**SUBDIVISION,
PLANNED UNIT DEVELOPMENT,
PLANNING APPROVAL &
ZONING AMENDMENT STAFF REPORT****Date: March 15, 2018**

<u>NAME</u>	Historic Restoration Society, Inc.
<u>SUBDIVISION NAME</u>	Lone Oak Subdivision, Revision and Addition to
<u>LOCATION</u>	901, 903, 907, & 911 Dauphin Street and 2, 6, 10 & 14 South Broad Street (Southwest corner of Dauphin Street and South Broad Street, extending to the North side of Conti Street)
<u>CITY COUNCIL DISTRICT</u>	District 2
<u>PRESENT ZONING</u>	B-1, Buffer-Business District, B-2, Neighborhood Business District, and B-4, General Business District
<u>PROPOSED ZONING</u>	Lot 1: B-2, Neighborhood Business District (<i>no change of zoning</i>); and Lot 2: B-4, General Business District
<u>REASON FOR REZONING</u>	The subdivision of land.
<u>AREA OF PROPERTY</u>	2 Lots / 4.5 ± Acres
<u>CONTEMPLATED USE</u>	Subdivision approval to create 2 lots, Planned Unit Development Approval to allow multiple buildings on a single building site and shared access and parking between two building sites, Planning Approval to allow a float barn in a B-4, General Business District, and Rezoning from B-1, Buffer-Business District, and B-4, General Business District

SITE PLAN

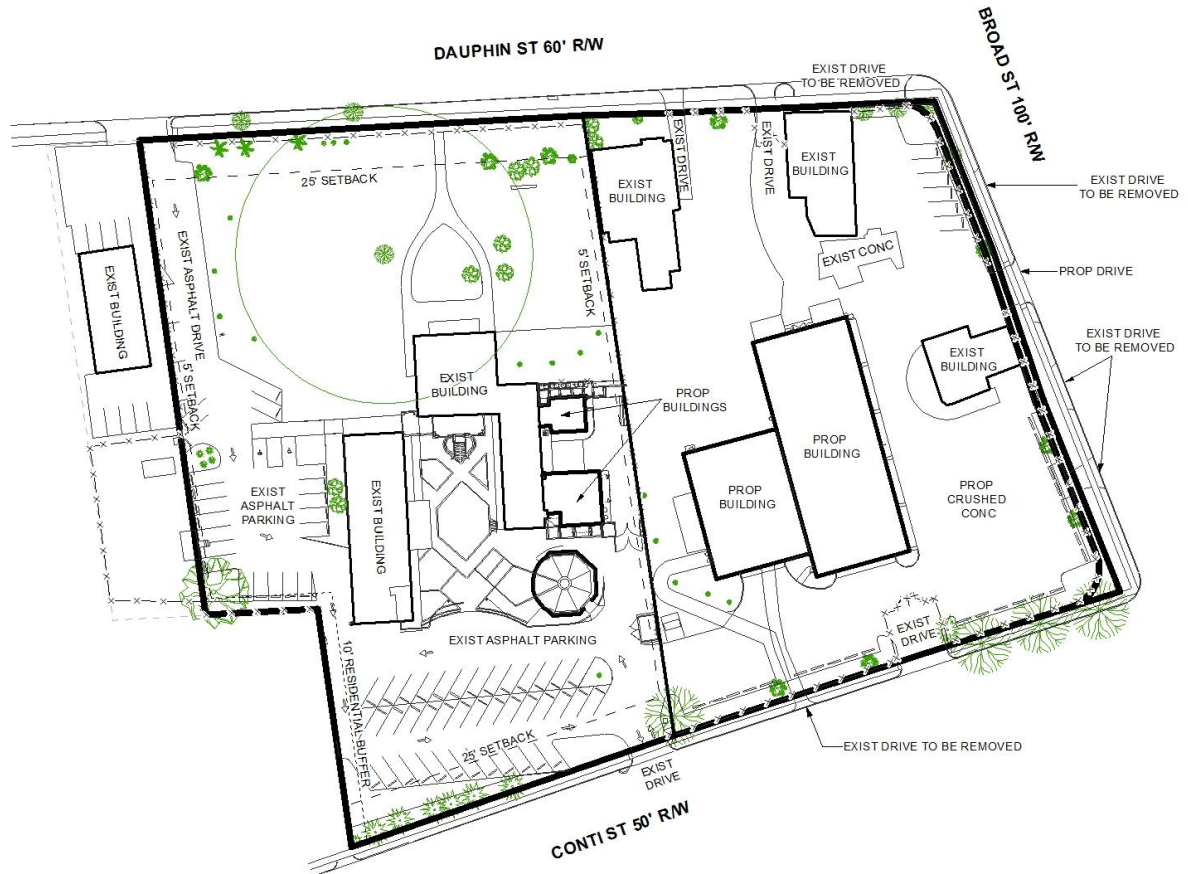
It appears that are proposed curb cuts shown exceed the number of curb cuts allowed as listed in PUD NOTE #1. Clarify the note and/or the proposed curb cuts.

The site has frontage onto Dauphin Street, Conti Street, and Broad Street. Dauphin and Broad Streets are proposed major streets, according to the Major Street Plan component of the Comprehensive Plan. The existing right of way of Dauphin Street is 60 feet, and the previous applications required modification of the minimum building setback line along Dauphin Street to reflect a proposed right-of-way width of 100 feet. As part of the adopted of the Future Land Use Map and associated Major Street Plan on May 18, 2017, the right-of-way width requirement for Dauphin Street was reduced to be the existing right-of-way, thus a standard 25-foot minimum building setback will be sufficient on Lot 1 (the B-2 property) along Dauphin Street, and a 0-foot minimum building setback for proposed Lot 2 (the proposed B-4 property) along Dauphin Street. The preliminary plat reflects this reduction, but the PUD and Planning Approval site plans do not.

Access management is a concern due to the site's location and frontage onto three streets. The site plan provided with the applications depicts that two gated curb-cuts to Dauphin Street will remain, and the driveway associated with the 907 Dauphin Street structure and that the existing 67-foot long curb-cut adjacent to 903 Dauphin Street will remain. One gated curb-cut to Broad Street is proposed to be retained, and two gated curb-cuts onto Conti Street are proposed to be retained. All other curb-cuts are labelled as to be removed and replaced with curb-and-gutter.

It should be noted that the site plan does not appear to be accurate. A site visit by staff observed that the construction office trailer has been relocated from behind 919 Dauphin Street to proposed Lot 2, and that a large portion of the fence separating 919 Dauphin Street from 911 Dauphin Street has been removed, allowing full pedestrian access between the two properties.

Staff also observed that the rear of the two residential properties at 918 and 920 Conti Street are being used for reserved parking spaces – that there are gates in the fence separating 911 Dauphin Street from the properties. Use of the residential properties for the 911 Dauphin Street site was

of concern when the original event/meeting hall rezoning was proposed in 2014, and thus the properties were purposefully excluded from the original PUD, Zoning and Subdivision applications, yet it appears that they are being used anyway.

Therefore, if it is the intention of the applicant to utilize 919 Dauphin Street, and 918 and 920 Conti Street as part of the overall development, these properties should be included in the PUD, Subdivision and Zoning applications.

- 1) Revision of the site plan to include 919 Dauphin Street, and 918 and 920 Conti Street;
- 2) Submittal of labels and postage by March 26th so that appropriate notification of all property owners can occur for the PUD application, including the expanded PUD site; and
- 3) Revision of the site plan to reflect the minimum building setback lines shown on the preliminary plat, and to depict dedication along Broad Street

- 1) Revision of the site plan to include the proposed use of 907 Dauphin Street, and reflect any changes being made to the PUD site plan.
